## **Field Bill of Material (FBM)**

**PN 76F9040**

### **EXCHANGE the CADR Card in IBM 3745 Models 210/310/410/610 and IBM 3746 Model A11**

3745 FBM	PN 76F9040 1 of 14	EC A98181B 05JUN91	EC C38405 06APR93	EC H10030E 06FEB04		
-------------	-----------------------	-----------------------	----------------------	-----------------------	--	--

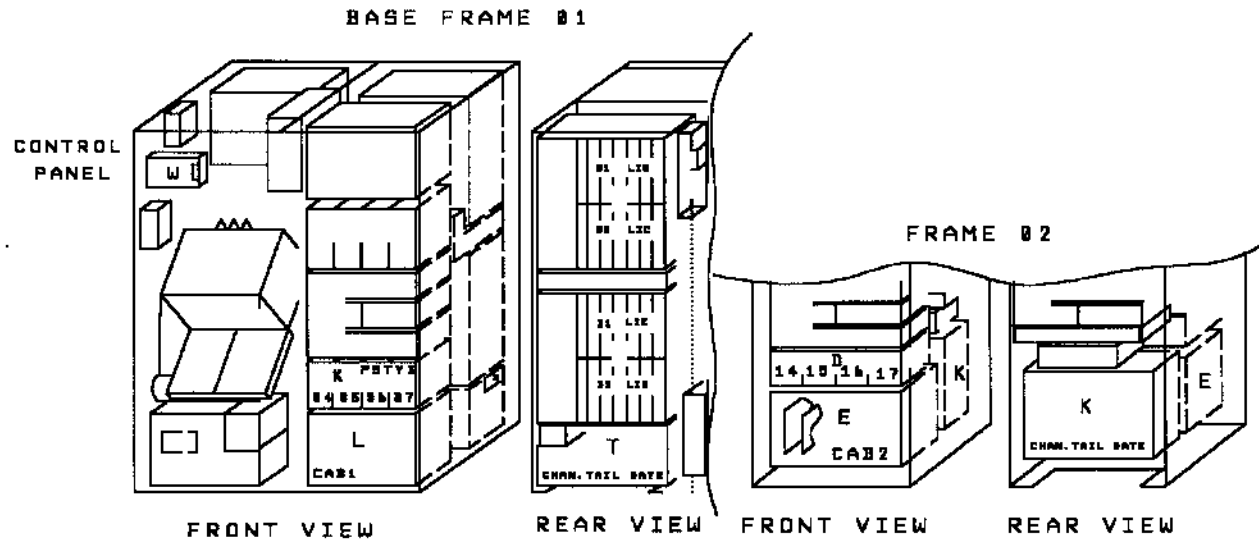
- \_\_\_ 7. Open the shield B.
- \_\_\_ 8. Identify the CADR card(s) position according to the CA number you have selected (see tables in section 4).
- \_\_\_ 9. Remove crossovers from the top of CA cards and unplug the CADR card(s).
- \_\_\_ 10. If the CA has TPS, remove 4 crossovers.

- \_\_\_ 11. Verify the card holder is installed on the new CADR card(s) PN 76F8487 and install the new CADR card(s) in board.
- \_\_\_ 12. Re-plug the crossovers on top card connectors.
- \_\_\_ 13. From rear of the 3745, place the SELECT-OUT BYPASS switch to the NORMAL position.
